**COPPLE CROWN VILLAGE DISTRICT
WATER TREATMENT SYSTEM
BOOSTER STATION UPGRADE
NEW DURHAM, NEW HAMPSHIRE**

ADDENDUM #1

DATE: JULY 19, 2024
TO: PLAN HOLDERS

TYPICAL WATER TRENCH DETAIL
NOT TO SCALE

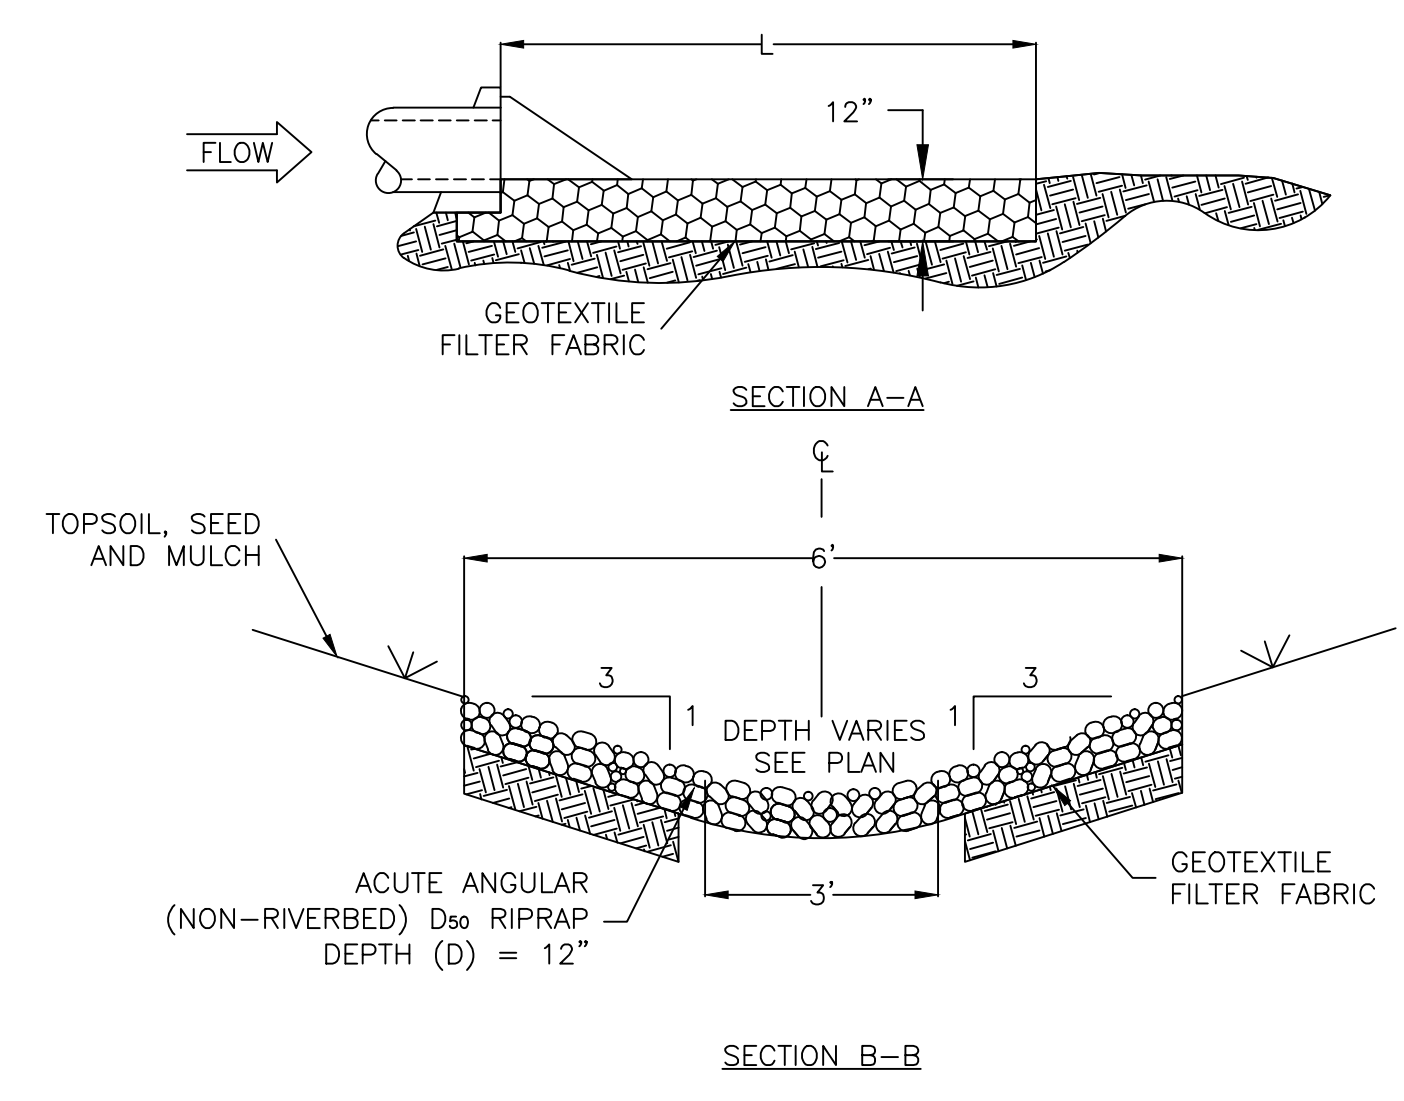
- c. Trench details regarding watermain piping shall follow manufacturer's recommendations and Env-Dw 405 Design Standards for Small Community Water Systems.
